Form C-103  
May 27, 2004

WELL API NO. 30-025- <del>09073</del> 09194
5. Indicate Type of Lease <u>Federal</u> STATE <input type="checkbox"/> FEE <input type="checkbox"/>
6. State Oil & Gas Lease No. 025432
7. Lease Name or Unit Agreement Name South Eunice Unit
8. Well Number 43
9. OGRID Number 002799
10. Pool name or Wildcat Eunice 7 Rivers Queen, South

SUNDRY NOTICES AND REPORTS ON WELLS (DO NOT USE THIS FORM FOR PROPOSALS TO DRILL OR TO DEEPEN OR PLUG BACK TO A DIFFERENT RESERVOIR. USE "APPLICATION FOR PERMIT" (FORM C-101) FOR SUCH PROPOSALS.)

UNITED STATES  
DEPARTMENT OF THE INTERIOR  
BUREAU OF LAND MANAGEMENTFORM APPROVED  
OMB No. 1004-0137  
Expires: March 31, 2007**SUNDRY NOTICES AND REPORTS ON WELLS***Do not use this form for proposals to drill or to re-enter an abandoned well. Use Form 3160-3 (APD) for such proposals.***SUBMIT IN TRIPLICATE- Other instructions on reverse side.**1. Type of Well  
☐ Oil Well ☐ Gas Well ☒ Other2. Name of Operator **Breck Operating Corp.**3a. Address  
**P.O. Box 911, Breckenridge, TX 76424**3b. Phone No. (include area code)  
**254-559-3355**

Current Well Status

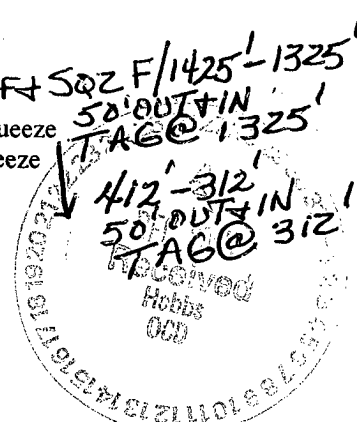
- Circ CIBP w/35' @ 3500'
- Circ w/mud
- 100' plug 3000'-2900'
- 100' plug 1525'-1425' PERF SQZ F/1425'-1325'
- 100' plug 350'-250' perf & squeeze 50' OUT IN TAG @ 1325'
- Surface plug 60'-0' perf & squeeze
- Install Dry Hole Marker
- Clean Location
